Contract #: 04-0120F4Cty: SF/ALA Rte: 80 PM: 13.2/13.9File #: 69.25B**QUALITY ASSURANCE -- NON-CONFORMANCE REPORT****Location:** Changxing Island, Shanghai, P.R. China**Report No:** NCR-000537**Prime Contractor:** American Bridge/Fluor Enterprises, a JV**Date:** 17-Dec-2009**Submitting Contractor:** Zhenhua Port Machinery Company, Ltd (ZPMC), Changxing Island**NCR #:** ZPMC-0510**Type of problem:**

**Reference Description:** Base Metal Repair without Engineer's Approval, Side Panel SP205A, Crossbeam CB8**Description of Non-Conformance:**

<b>To:</b>	AMERICAN BRIDGE/FLUOR, A JV 375 BURMA ROAD OAKLAND CA 95607	<b>Date:</b>	24-Dec-2009
<b>Dear:</b>	Mr. Charles Kanapicki	<b>Contract No:</b>	04-0120F4 04-SF-80-13.2 / 13.9
<b>Attention:</b>	Mr. Thomas Nilsson Project/Fabrication Manager	<b>Job Name:</b>	SAS Superstructure
<b>Subject:</b>	NCR No. ZPMC-0510	<b>Document No:</b>	05.03.06-000498

## NCR PROPOSED RESOLUTION

**Reference Description:** Base Metal Repair without Engineer's Approval, Side Panel SP205A, Crossbeam CB8

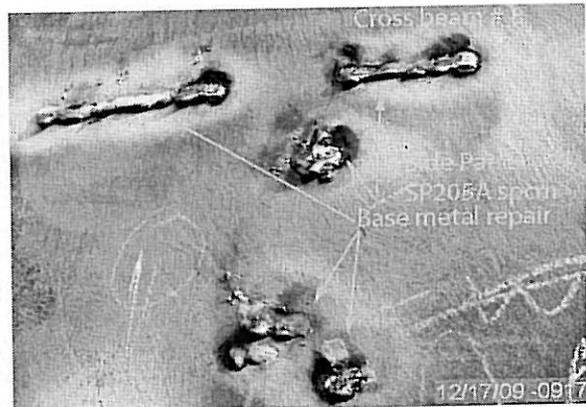
During a random visual inspection of the Orthotropic Box Girder (OBG) Crossbeam CB8, the Caltrans Quality Assurance (QA) Inspector observed ZPMC personnel performing un-approved Seismic Performance Critical Member (SPCM) base metal repairs on the Side Panel (SP) of Crossbeam CB8 without the Engineer's approval.

- The BP was identified as: BP205A
- The SP was identified as: SP205A
- The weld number between the SP and BP is identified as: CB202A-008-017
- The material utilized is A709 Grade 345 SPCM.
- The welding process used was SMAW.

Reference Description: SPCM base material repair on CB8 performed without prior Engineer's approval

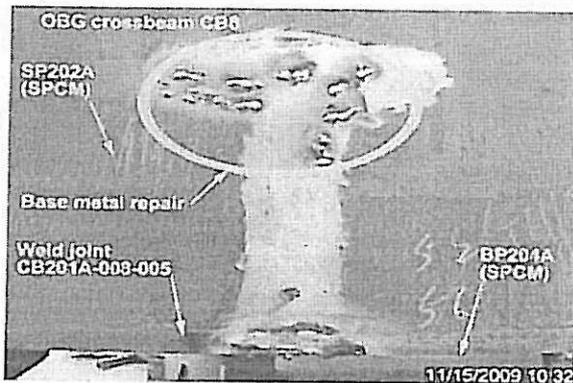
This Quality Assurance (QA) inspector observed ZPMC personnel performing base metal weld repairs on material designated as SPCM on the approved shop drawings without prior Engineer's approval. The areas being repaired were damaged while removing temporary lifting lug welds at the corners of this crossbeam. The component is identified as Orthotropic Box Girder (OBG) crossbeam CB8. The Seismic Performance Critical Member (SPCM) panels affected are identified as side panel SP202A and bottom panel BP204A.

1. AWS D1.5 2002 section 3.3.7.3 "Tack welds not incorporated into the final weld shall be removed in such a manner that the base metal is not nicked or undercut. Repair of base metal accidentally removed shall be approved by the Engineer prior to making the repair.

2. AWS D1.5 2002 section 3.7.4 "Prior approval of the Engineer shall be obtained for repairs to base metal..."

**Reference Description:** Base Metal Repair without Engineer's Approval, Side Panel SP205A, Crossbeam CB8

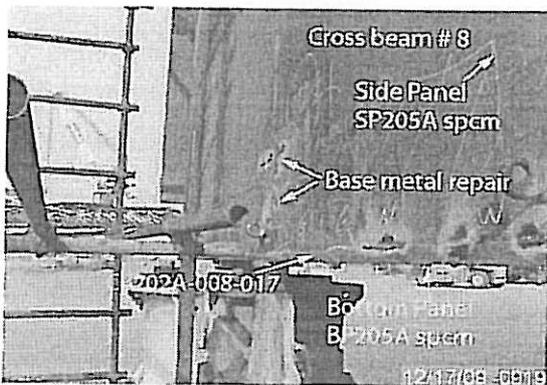
During a random visual inspection of the Orthotropic Box Girder (OBG) Crossbeam CB8, the Caltrans Quality Assurance (QA) Inspector observed ZPMC personnel performing un-approved Seismic Performance Critical Member (SPCM) base metal repairs on the Side Panel (SP) of Crossbeam CB8 without the Engineer's approval.

- The BP was identified as: BP205A
- The SP was identified as: SP205A
- The weld number between the SP and BP is identified as: CB202A-008-017
- The material utilized is A709 Grade 345 SPCM.
- The welding process used was SMAW.
